**BOARD OF COMMISSIONERS**  
*Special Board Meeting Agenda*

<b>Agenda Topic Title for Publication:</b>	<b>Historic Rockwall Project - Proposal #1</b>
--	--

Project: Todd County Rock Wall

**RE: Proposal #1 - Additional Work at the Todd County Rock Wall Project.**

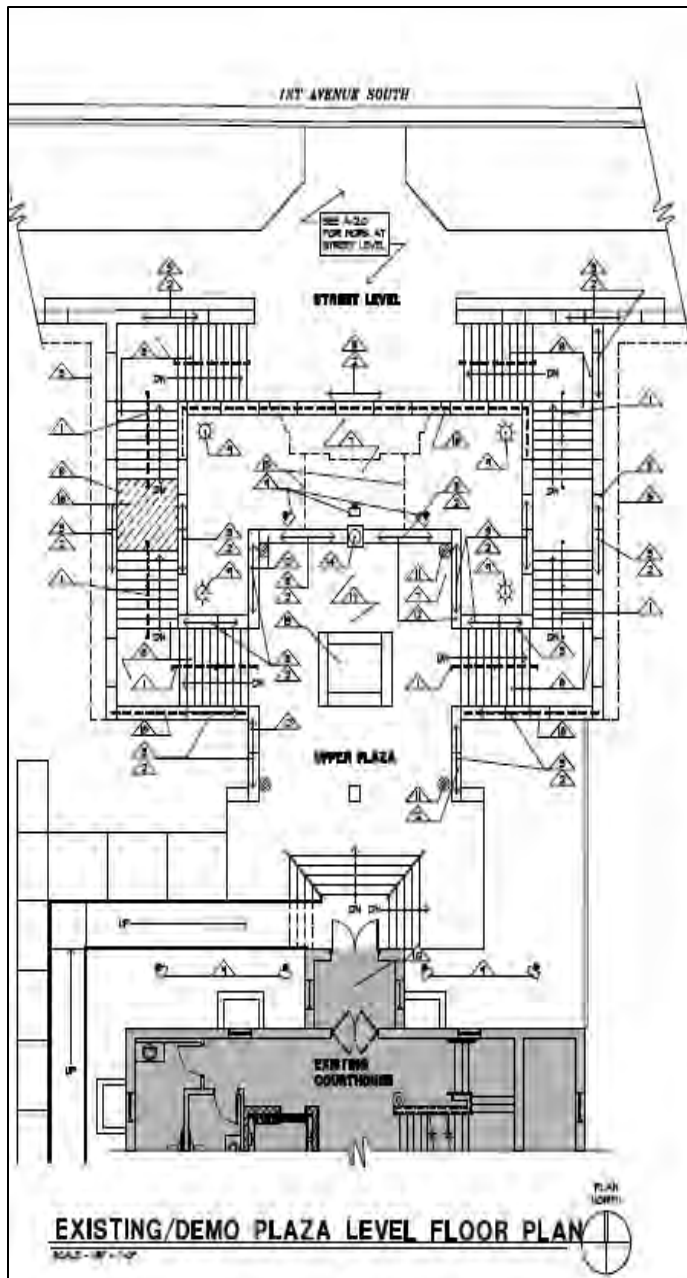
**East Wall (area east of capped north entry walls along 1<sup>st</sup> Avenue South)**

Rebuild Walls	Add 136 SF @ \$200.00/SF	\$27,200.00
---------------	--------------------------	-------------

**North Entry Walls (capped north entry walls along 1<sup>st</sup> avenue south)**

Rebuild Walls	Add 605 SF @ \$200.00/SF	\$121,000.00
New Capstone	Add 341 LF @ \$350.00/LF	\$119,350.00

**West Wall (area west of capped north entry walls along 1<sup>st</sup> avenue south and 2<sup>nd</sup> street south)**

Rebuild Walls	Add 450 SF @ \$200.00/SF	\$90,000.00
Tuckpointing Top of Wall	Add 900 SF @ \$85.00/SF	\$76,500.00

The difference between planned and anticipated work is currently taped on the walls and photos have been taken to highlight the difference.
